Planning for People with Disabilities objection & alternative suggestions

Proposed Traffic Regulation Order New Road (Disabled Parking)

Comments and Proposals regarding the reduction
of Disabled Parking Bays in New Road

Paragraph 4.1 of the British Standard states

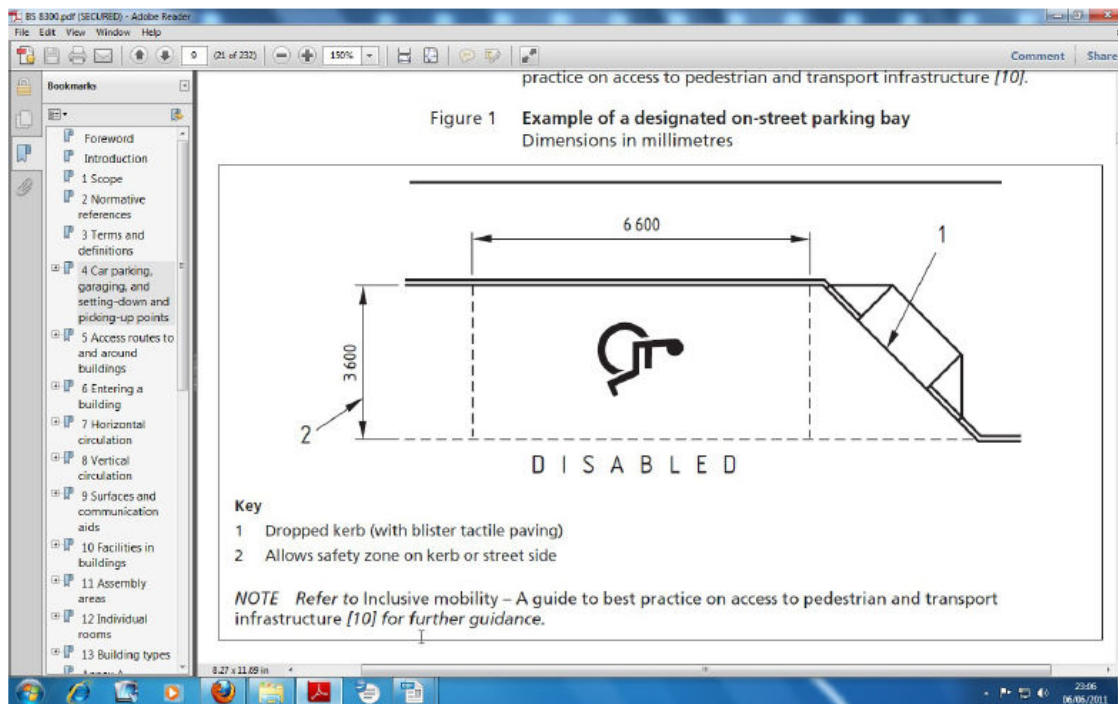
Currently there are 4 bays in a length of 27m = 6.75 m/bay which conform to BS 8300. Proposed there will be 3 bays in a length of 15m = 5.00 m/bay **which do not conform.**

A five metre bay falls far short of the 6.6m length for parallel Disabled Bays contained within British Standard BS 8300:2009. In consequence only two cars will be able to park in the remaining length, and the Disabled Parking capacity of this road is halved.

- The dimensions of such parking bays, parallel to the kerb, should be as shown in Figure 1, to permit access to the rear of a vehicle to use a ramp or tail lift and to enable the driver or passenger to alight on the side where traffic might be passing.

- **At the initial Planning and Design of this Shared Surface project several years ago, Disabled Parking needs were addressed – reducing this by half is not acceptable.**
- **In consequence, we will only support the Proposal if two replacement Bays are provided.**
- Four suggestions for their positioning are shown overleaf, but more can be proposed if there are valid reasons why these proposals are deemed not suitable.
